**COMMUNICATION C8**

**VAUGHAN COMPREHENSIVE ZONING BY-LAW - FINAL DRAFT - TOROMONT INDUSTRIES LTD. COMMENTS**

IBI Group are the planning consultants for Toromont Industries Ltd. (herein referred to as 'our clients') who own approximately 27-acres of land south of Highway No.7, west of Jane Street, north of Highway 407 and east of Highway 400, within the Vaughan Metropolitan Centre (VMC), in the City of Vaughan.

**Figure 1. Landmark Locations from Schedule A2 of Zoning By-law 1-88**

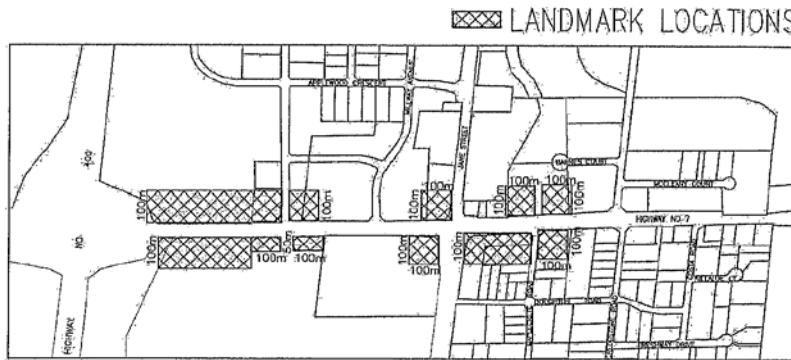
IBI Group would also like to highlight that notable provisions from Zoning By-law 1-88 are missing from the current Draft Comprehensive Zoning By-law, including the Landmark Location provision from Schedule A2 of Zoning By-law 1-88 (**Figure 1**). This provision permits unlimited height in certain locations along Highway 7 to serve as a gateway to the Highway 7 corridor. IBI Group is not supportive of the exclusion of these provisions from the Comprehensive Zoning By-law and wish to see them included in the Second Draft. Several towers have already been approved and/or constructed along Highway 7 within the Landmark Locations, setting a precedent for the built-form along this corridor. The removal of these provisions will create a disconnect between the built-form, conflicting with several of the City’s Urban Design objectives and creating great variations in height and density.

**Figure 1. Landmark Locations from Schedule A2 of Zoning By-law 1-88**

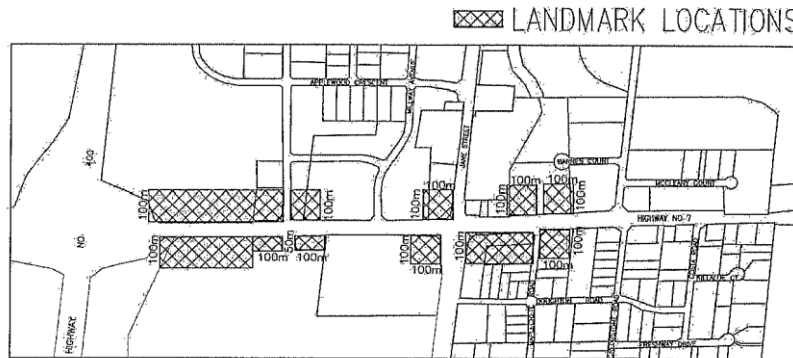
IBI Group would also like to highlight that notable provisions from Zoning By-law 1-88 are still missing from the Second Draft Comprehensive Zoning By-law, including the Landmark Location provision from Schedule A2 of Zoning By-law 1-88 (**Figure 1**). This provision permits unlimited height in certain locations along Highway 7 to serve as a gateway to the Highway 7 corridor. IBI Group is not supportive of the exclusion of these provisions from the Comprehensive Zoning By-law that essentially downzone the parcels and wish to see them included in the Final Draft. The removal of these provisions will create a downzoning that is inconsistent with provincial policy related to urban growth centres and MTSAs.

**Figure 1. Landmark Locations from Schedule A2 of Zoning By-law 1-88**

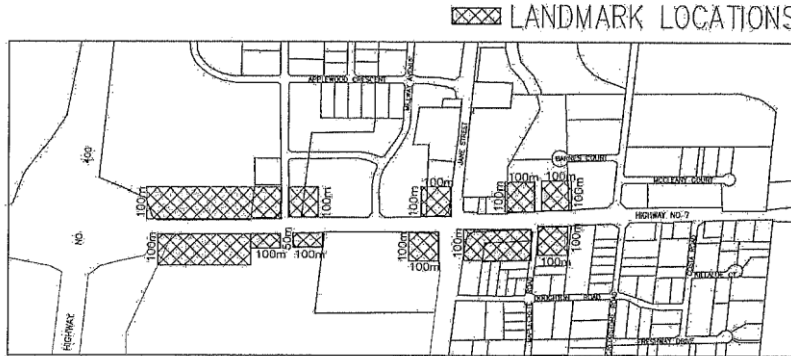
IBI Group would also like to highlight that the notable Landmark Location provision from Schedule A2 of Zoning By-law 1-88 is missing from the Third Draft CZBL. This provision permits unlimited height in key locations along Highway 7 to encourage the development of “landmark buildings”, serving as gateways into the VMC (**Figure 1**). The exclusion of these historic provisions from the CZBL essentially downzones the parcels which is inconsistent with provincial policy related to urban growth centres and MTSAs. We wish to see them included in the Final Draft.
